UNITED STATES PATENT AND TRADEMARK OFFICE

| APPLICATION NO. | FILING DATE | FIRST NAMED INVENTOR | ATTORNEY DOCKET NO. | CONFIRMATION NO. |
|-----------------|-------------|----------------------|---------------------|------------------|
| 09/883,941 | 06/20/2001 | Seiji Umemoto | Q65071 | 2681 |

Office Action Summary

DETAILED ACTION

【 図 1 】

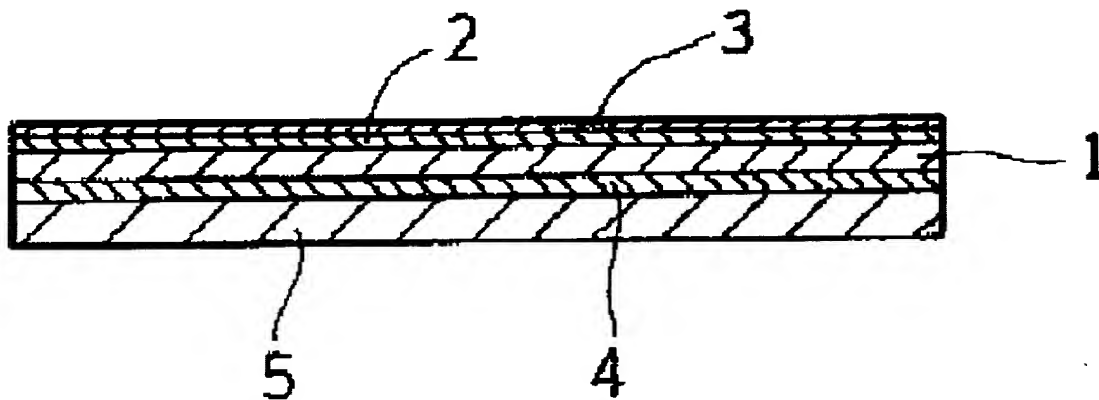
5. Claims 1-4 and 7 are rejected under 35 U.S.C. 102(b) as being anticipated by Shozo et al., (Shozo), JP 06-222352 (provided by the applicant).
6. Shozo discloses a resin substrate wherein a transparent resin plate (1) has at least a transparent conductive layer (3) via a dielectric thin film (2) (applicant's

transparent layer) with a lower refractive index (n_2) than the resin plate (1) (abstract; Fig. 1).

Accordingly, claims 1 and 4 are anticipated.
